Subject: **WATER AND WASTEWATER CAPACITY AVAILABILITY LETTER**
1007 East Las Olas – DRC Case No. UDP-A24025
1007 E Las Olas Boulevard, Fort Lauderdale, FL 33301

City of Fort Lauderdale
Public Works Department
Water and Wastewater Capacity Analysis

1007 East Las Olas – DRC Case No. UDP-A24025
1007 E Las Olas Boulevard, Fort Lauderdale, FL 33301

Figure 1 – City Water Atlas

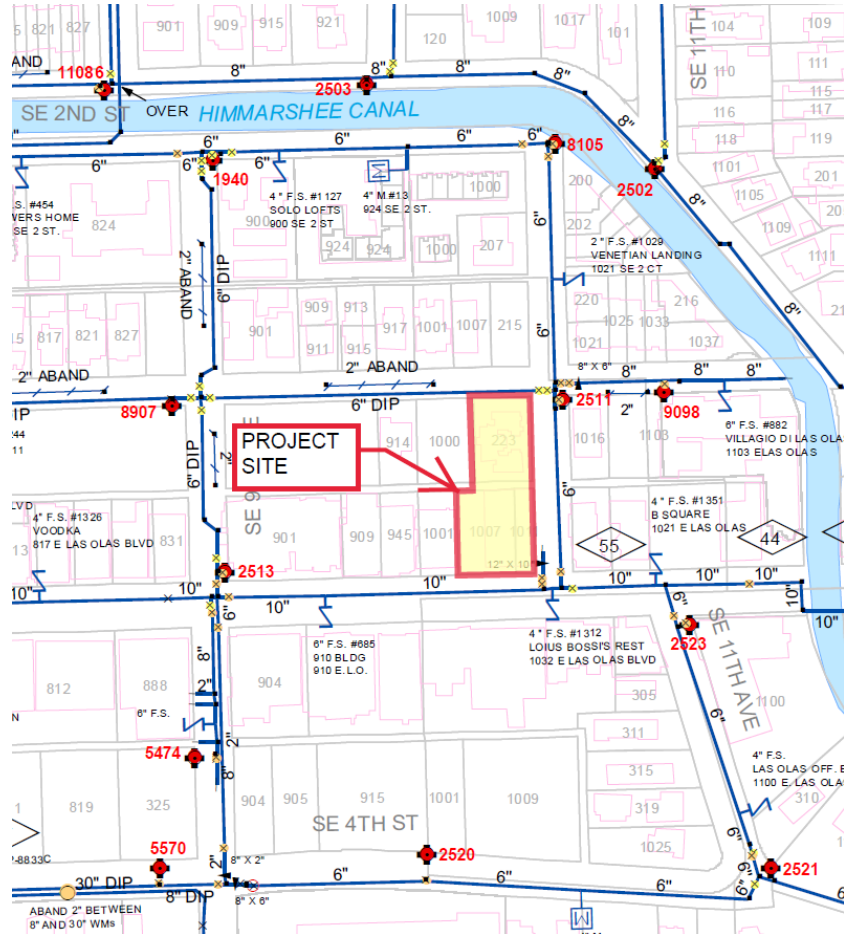
Water: The site is currently served by a 6-inch water main along SE 10th Terrace, east of the project site. See Figure 1.

Figure 2 – City Sewer Atlas

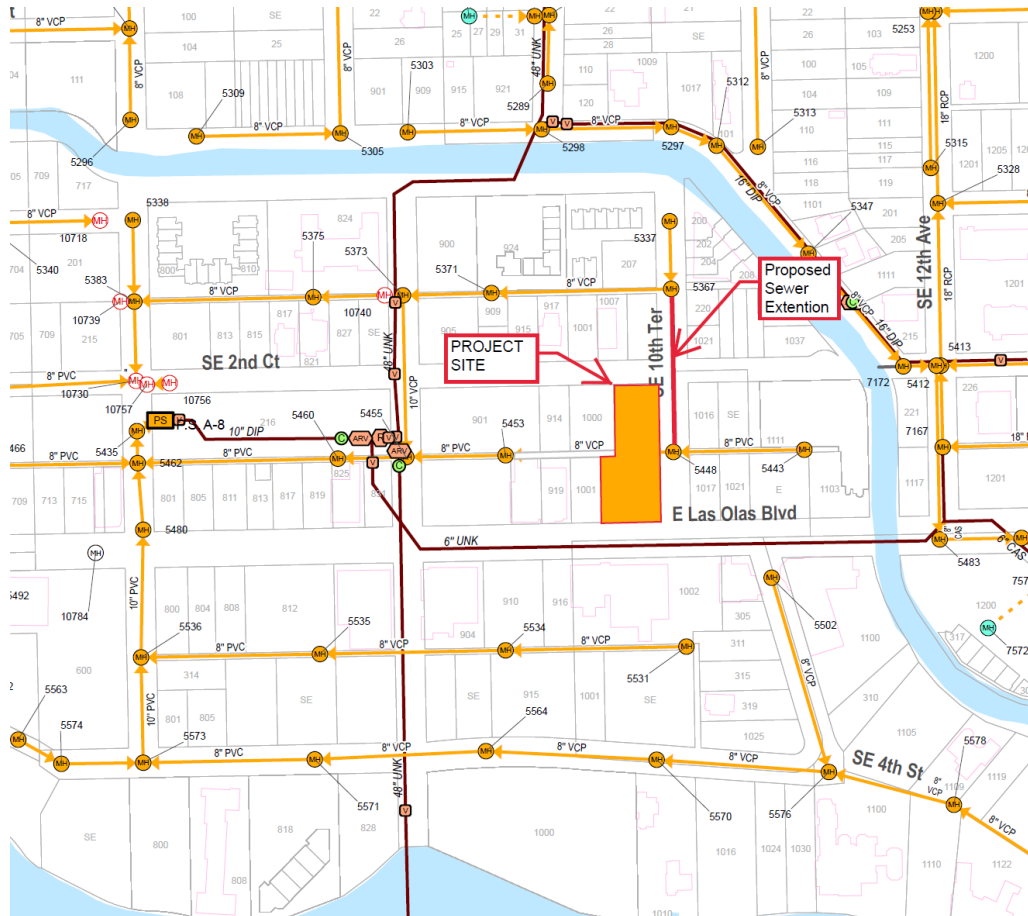
Wastewater: The site will be served by the proposed 8-inch gravity sewer extension along SE 10th Terrace to connect to existing sanitary sewer manhole SSMH-5367. See Figure 2.

The existing water and sewer infrastructure has the capacity to support the proposed development. No improvements are required, however, CCTV of the existing gravity sewer line connected to manhole SSMH-5367 must be taken before and after construction to ensure the integrity of the system.

Recommended Wastewater Infrastructure Improvements: No improvements are required, however, CCTV of the existing gravity sewer line connected to manhole SSMH-5367 must be taken before and after construction to ensure the integrity of the system.

Figure 3

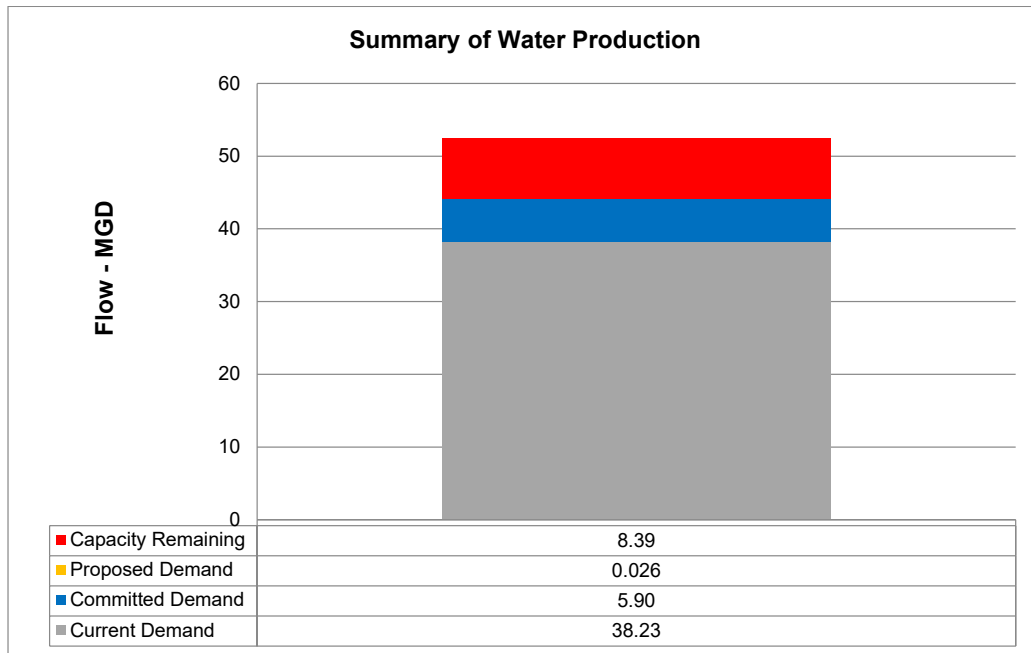
Evaluation of impact of Permitted Water Plant Capacity: The Fiveash and the Peele Dixie Water Treatment Plants are designed to treat 70 MGD and 12 MGD of raw water respectively (82 MGD total). The total permitted Biscayne aquifer water withdrawals for these plants is limited to 52.55 MGD per the South Florida Water Management District (SFWMD) permit number 06-00123-W.

The current twelve-month rolling average production at the two plants is 38.12 MGD. The previously committed demand from development projects in the permitting or the construction stage is 5.90 MGD. Combining these figures with the demand from the proposed project of 0.0260 MGD, the required production would be 44.05 MGD. This is less than the allowable withdrawal limit of 52.55 MGD. Therefore, the water plants have sufficient capacity to serve this project. See Figure 3 below.

Recommended Water Infrastructure Improvements: No improvements required.

Figure 4

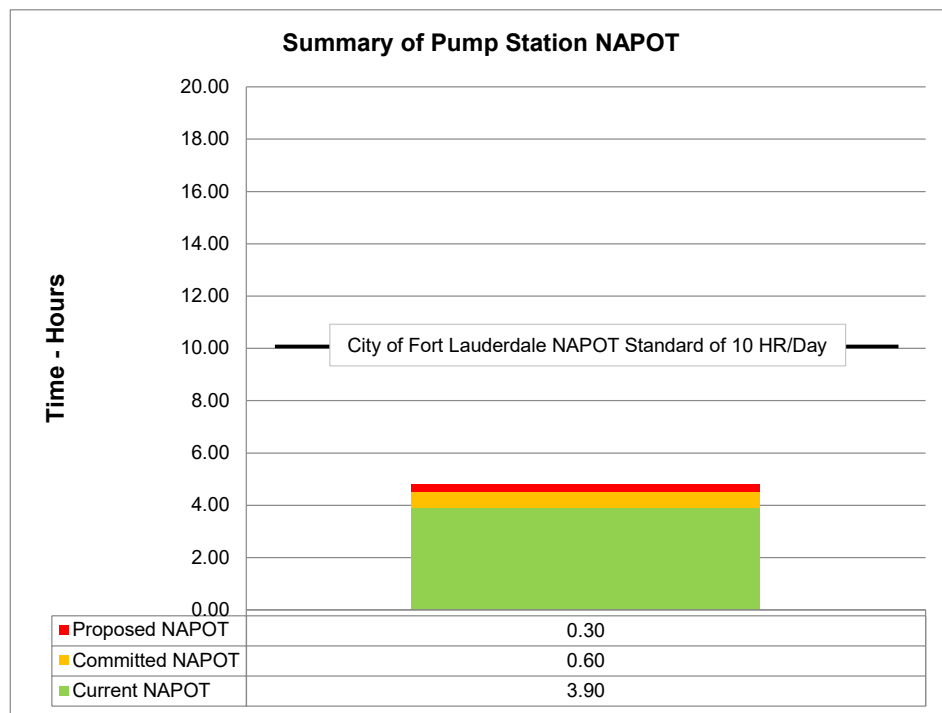
Evaluation of impact on pumping station: PS A-8 has a duty point of 1000 gallons per minute (GPM) and has a Nominal Average Pumping Operating Time (NAPOT) of approximately 3.90 hours per day. Based on projected sewage flows, the pumping run times would increase approximately 18 minutes per day. Additionally, there are other committed flows from proposed developments within the PS A-8 basin resulting in 35.99 minutes of additional runtime. PS A-8 will have a NAPOT of 4.79 hours once the proposed developments are complete, less than the recommended average of 10 hours per day. See Figure 4 below.

Figure 5

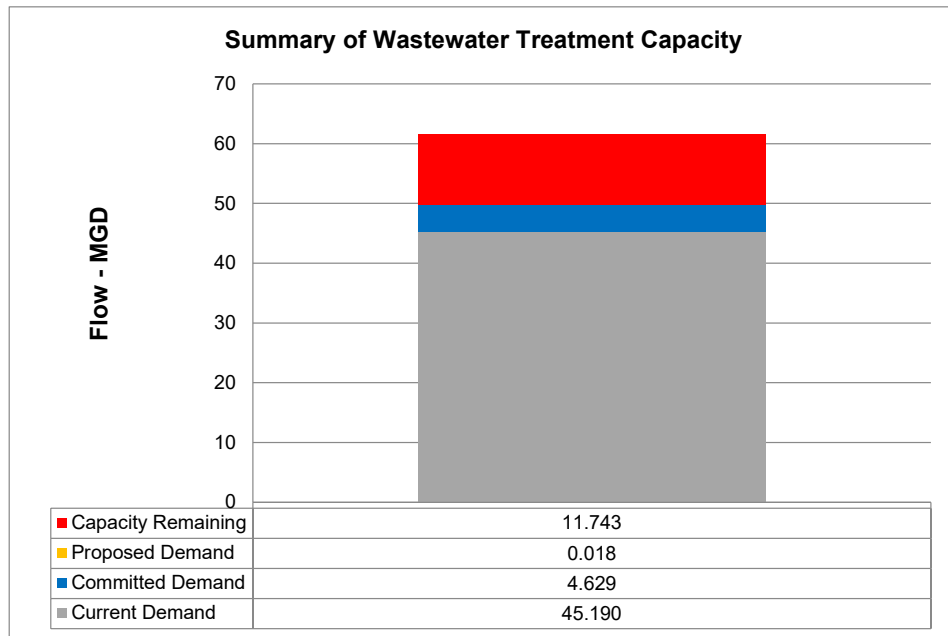
Evaluation of impact of Permitted Wastewater Plant Capacity: The City of Fort Lauderdale owns and operates the George T. Lohmeyer Regional Wastewater Treatment Plant (GTL), which provides wastewater treatment for the City of Fort Lauderdale. The Florida Department of Environmental Protection's (FDEP) permitted capacity for GTL is 61.58 MGD-TMADF (Million Gallons per Day – Three Month Average Daily Flow). The three-month average daily flow (TMADF) to the plant is 45.19 MGD. Combining the committed flows for previously approved projects of 4.63 MGD plus the 0.0179 MGD net contribution from the project results in a total projected flow of 49.84 MGD. This is less than the permitted treatment plant capacity of 61.58 MGD. Therefore, the treatment plant has sufficient capacity to serve this project. See Figure 5 below.
